PLAN SHOWING RENEWAL OF WOODEN ROOF INTO R.C.C. ROOF ON 3RD. FLOOR ON PLOT NO. 29.M.M.G.

KARACHI MUNICIPAL CORPORATION.**BUILDING SECTION.****REVIEW FORM.**

Case No. P/237/40

RE:—Plot No. 29, Sheet No. M.H-6, H. Mehmood Qr.

SITE PLAN

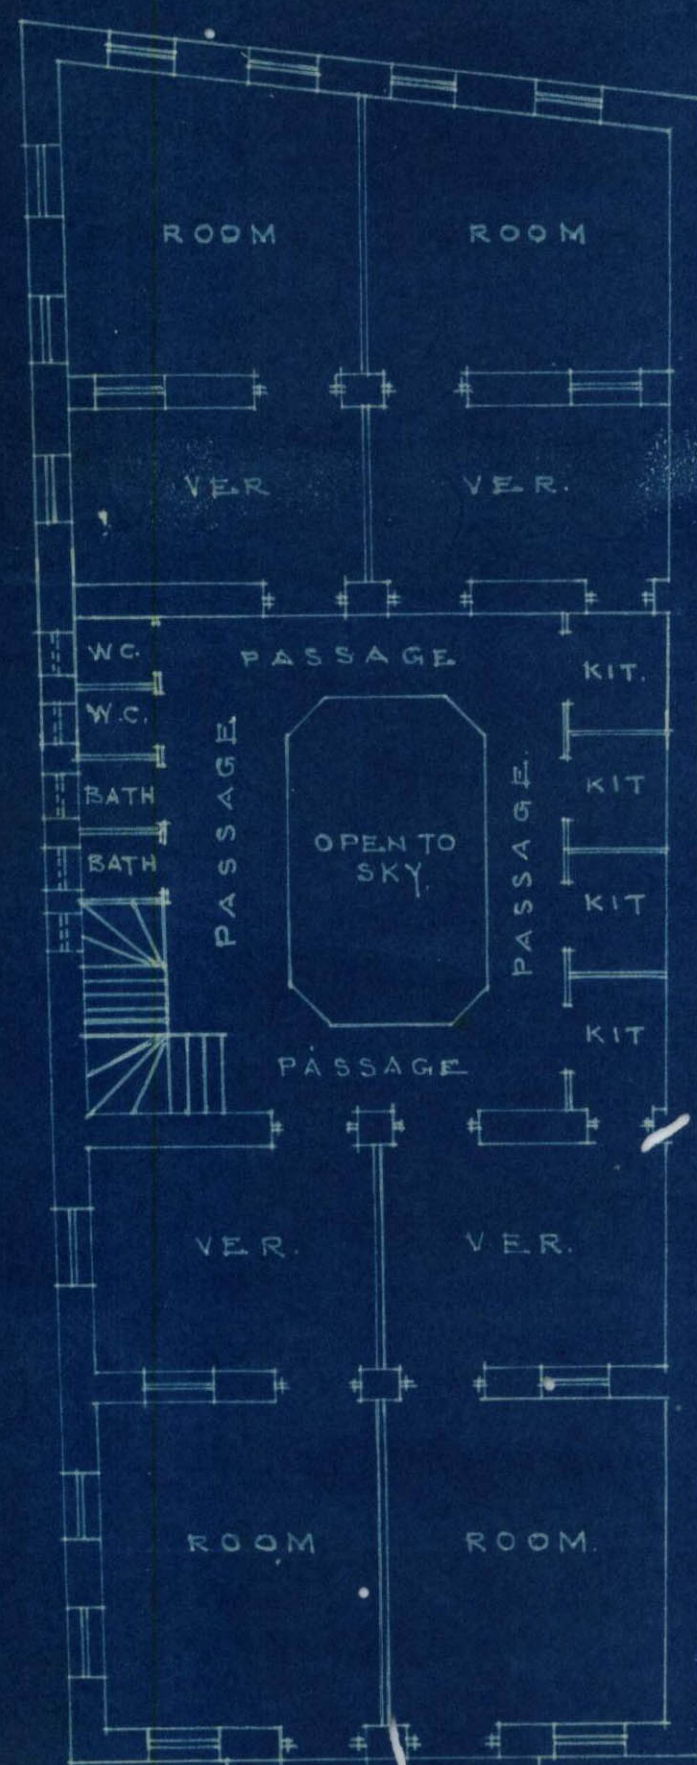
- (1) Measurement of the Eastern side be corrected.
- (2) Jaffer Jadoo Road width be corrected.
- (3) plot area be correctly shown.
no enrolment.

No objection to the site plan
as corrected.

TOP FLOOR

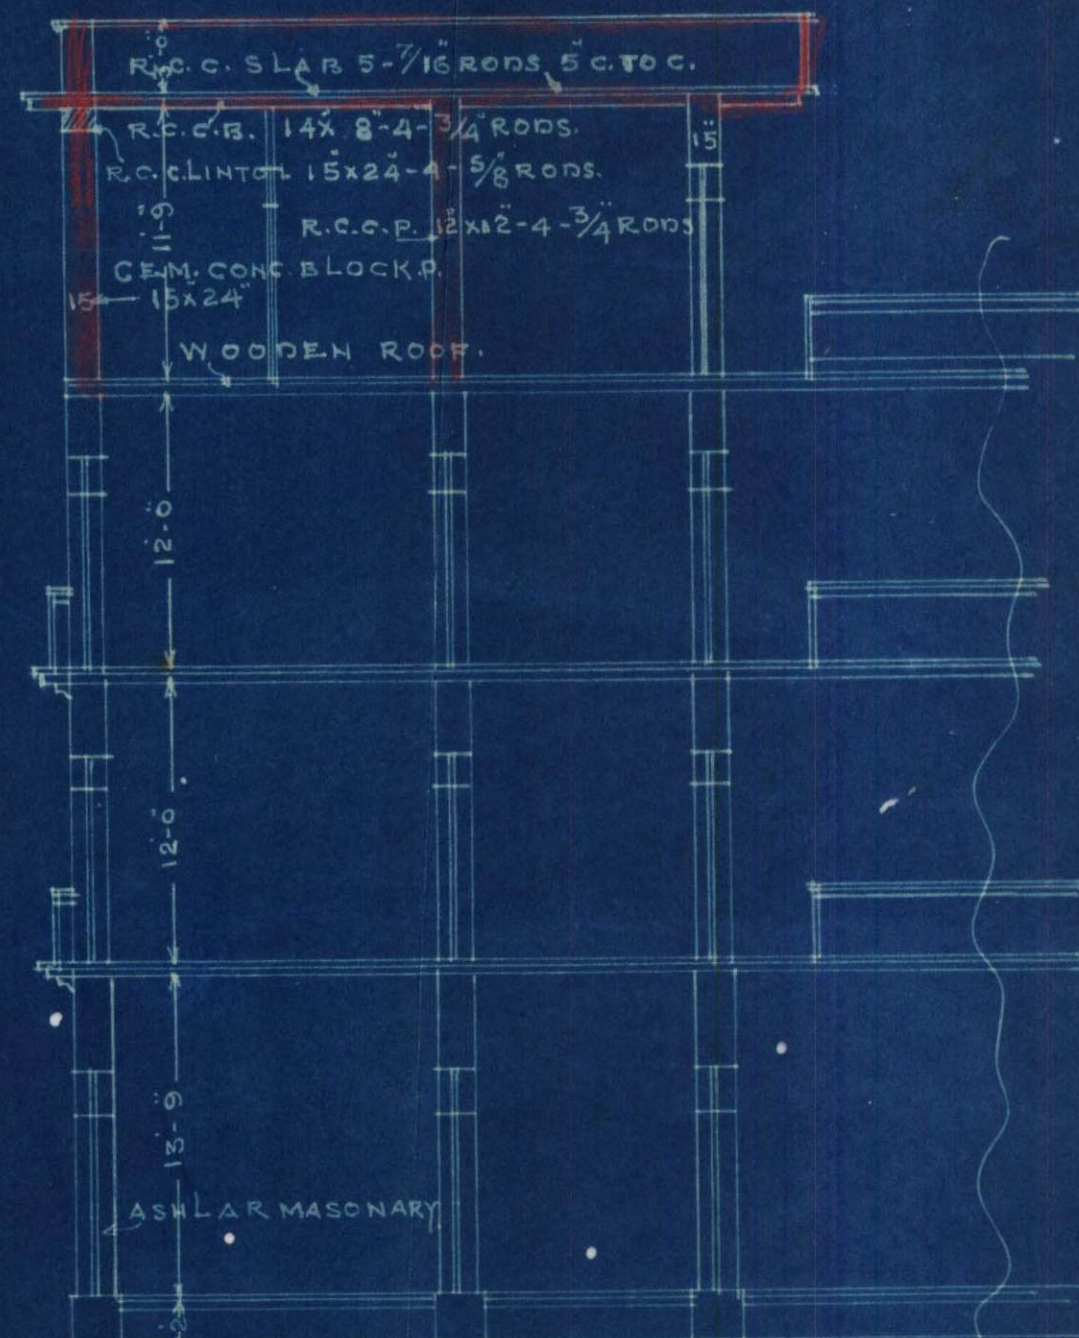
No objection to renewal
of roof & front wall on the top floor.
